**Town of Rotterdam
Planning Commission
July 18, 2023**

Re: *DAIM Logistics - Site Plan Application - Proposed Warehouse / Office*
681 Mariaville Road, Town of Rotterdam
CTMA Project No. 22.2224

Based upon the above and acting as Town Designated Engineer (TDE) for the project, CT Male offers the following review comments. These comments are intended as a first review of the Site Plan application package.

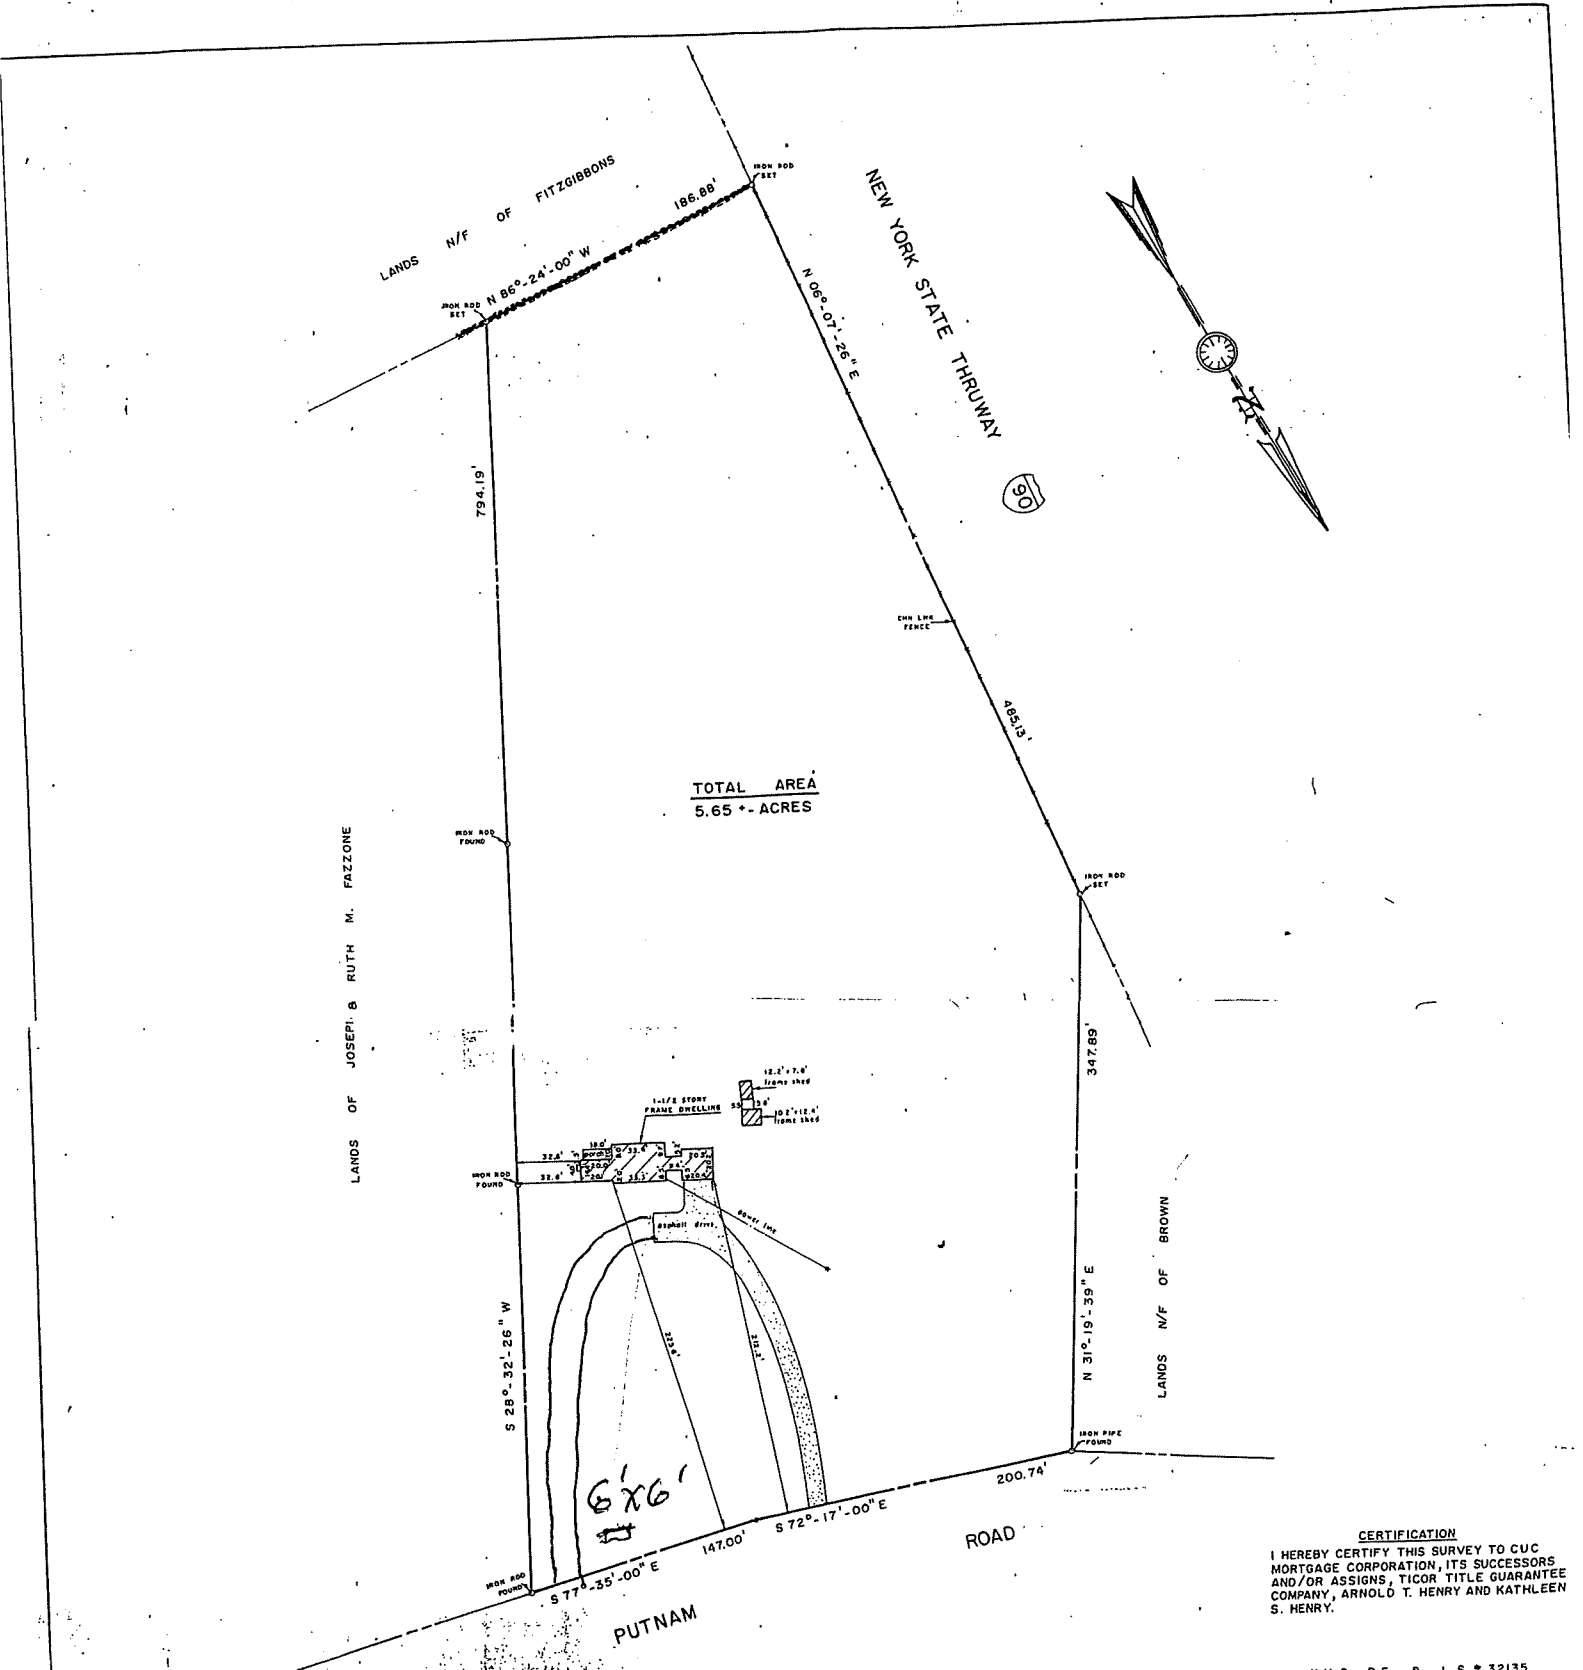
I am in receipt of your application for the above referenced project. Your Site Plan/survey does not indicate where you are placing the wood, parking, number of employees, business hours etc. as indicated on the application. Also, I need to know when you would like to sell the firewood. The Seasonal Sales Code, Chapter 228, of the Rotterdam Town Code allows for four (4) months (120 days).

Please update and submit a site plan with these items, a descriptive narrative, and let me know the time frame so I can place you on the next Planning Commission agenda which is July 18. I have attached the Seasonal Sales code for your use. If you have any questions, please let me know. Have a great day!
